VKMA 01250

Technical Bulletin - July 2012

FITTING RECOMMENDATIONS

Timing belt
TB01142

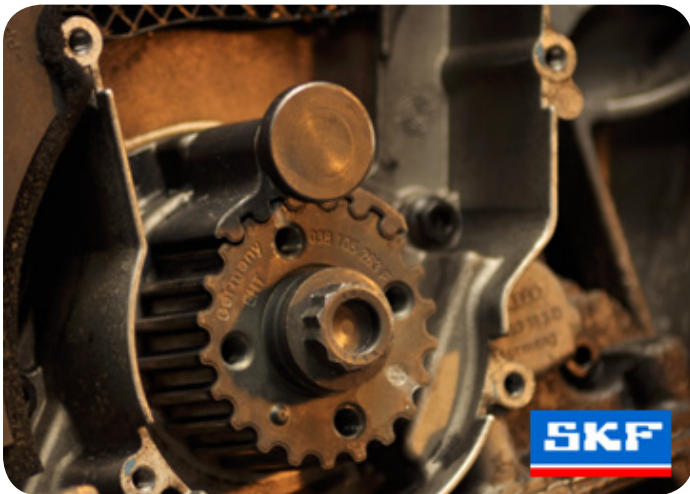
In line with OE evolution and specifications, the material of the belt included in the VKMA/C 01250 kits has been modified.

A PTFE – PolyTetraFluoroEthylene – coating has been applied to the new belt, which ensures stronger resistance and extends the timing belt kit replacement from 90,000 to 120,000 km (or 5 years, whichever is soonest).

Dependant on the kit production date; the coating could be black or white in colour. However, both offer the same performance level.
